MEMORANDUM

RE: PB 447 Clifton Link

PERCOLATION CERTIFICATION PLAN

CLIFTON C. LINK PROPERTY
 LOTS 10 & 11
 TAX MAP 34, GRID 9, PARCEL 368
 5TH ELECTION DISTRICT - HOWARD COUNTY, MARYLAND

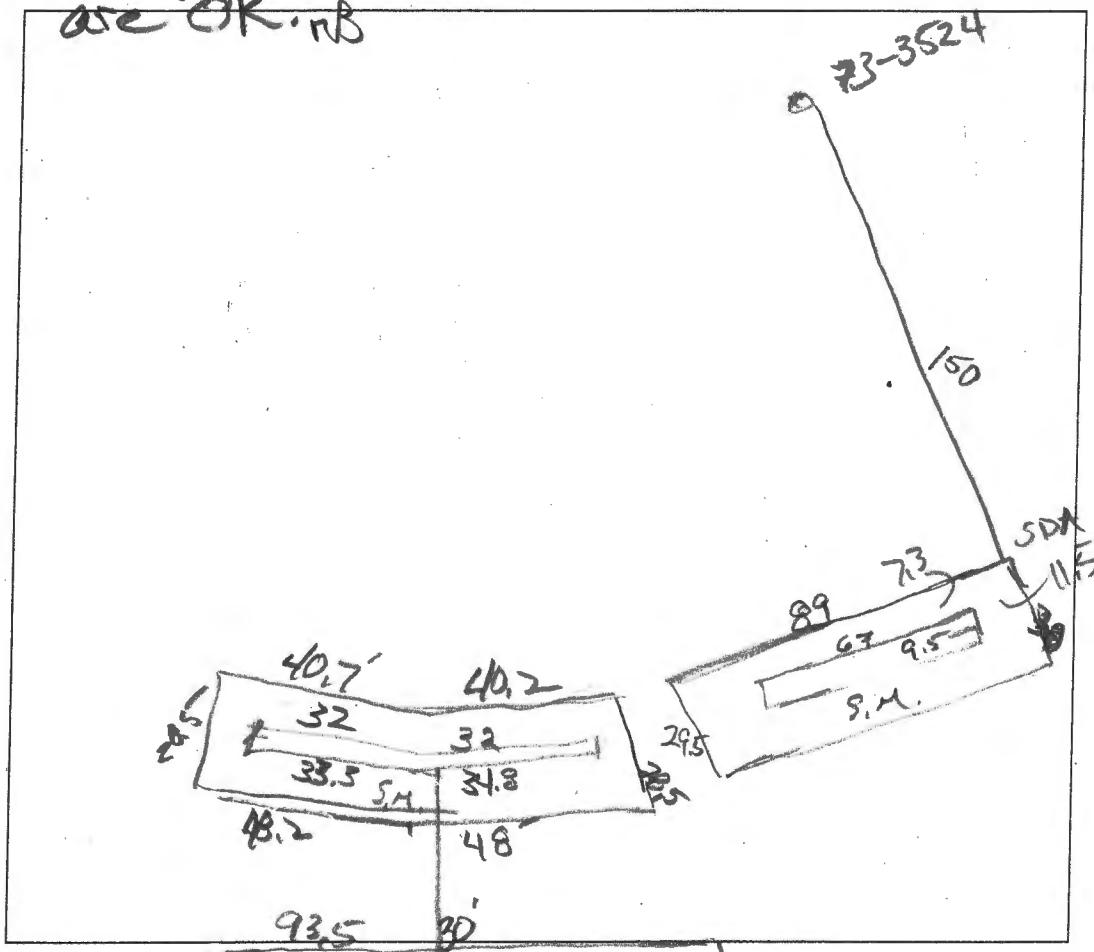
PROPOSAL: Field Review Sand Mound sites/SDA for 'lot 10'
for Perc Cent & Final Plat; layout and relative
elevations.
are OK. NB

COMMENTS: _____
_____ 89' 34' _____
_____ 93.2 _____
_____ in filtration strip _____
_____ 103.2 _____

SITE INSPECTION SHEET

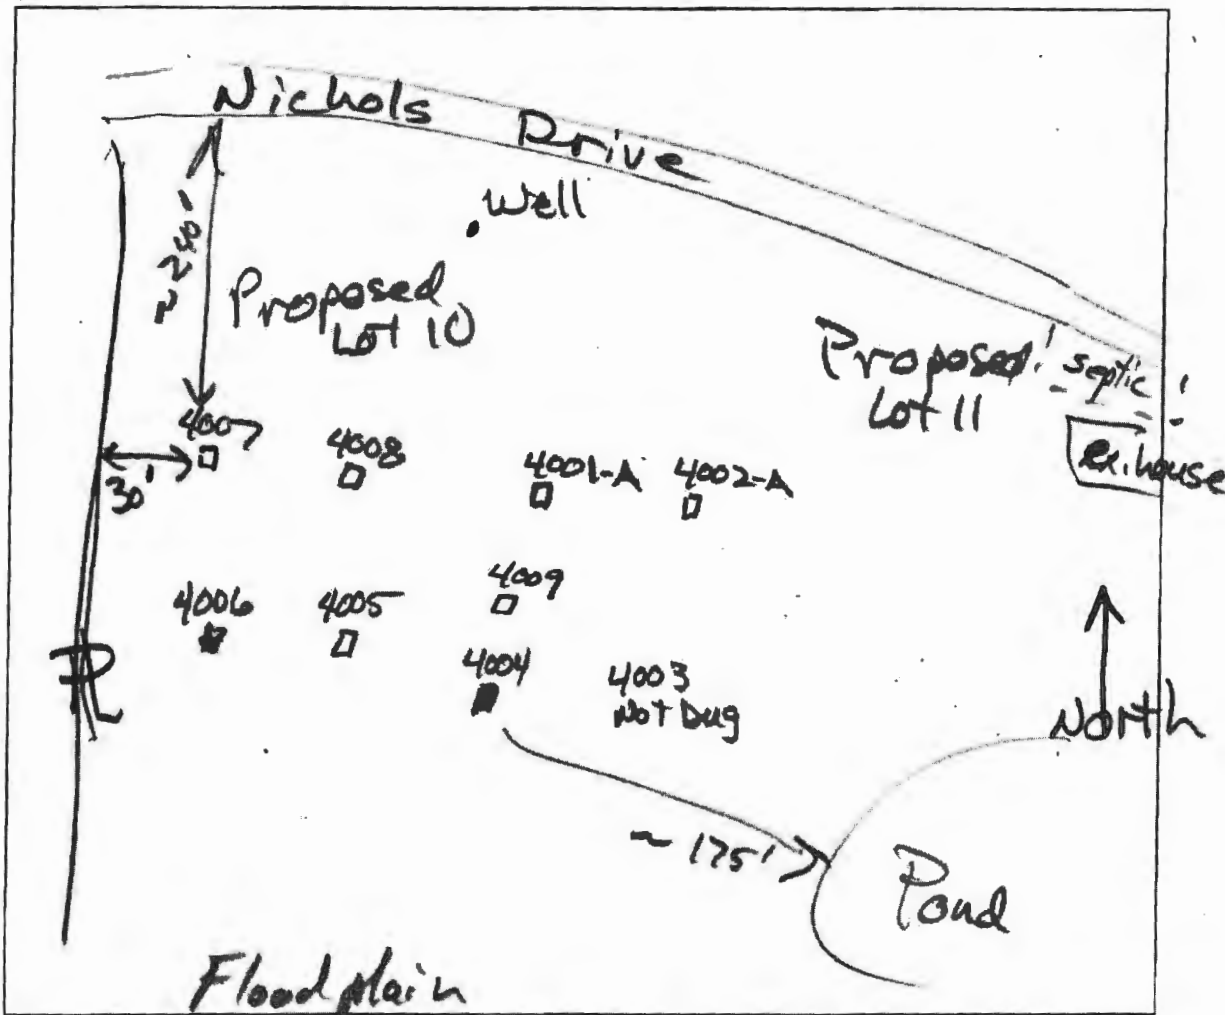
PROPOSAL: Infiltration tests to establish septic reserve for re-subdivision to lots 10 & 11 completed 4/23/12

COMMENTS: 2 Tests Fail; #4004 for water table within 24" of surface

6 Tests Pass
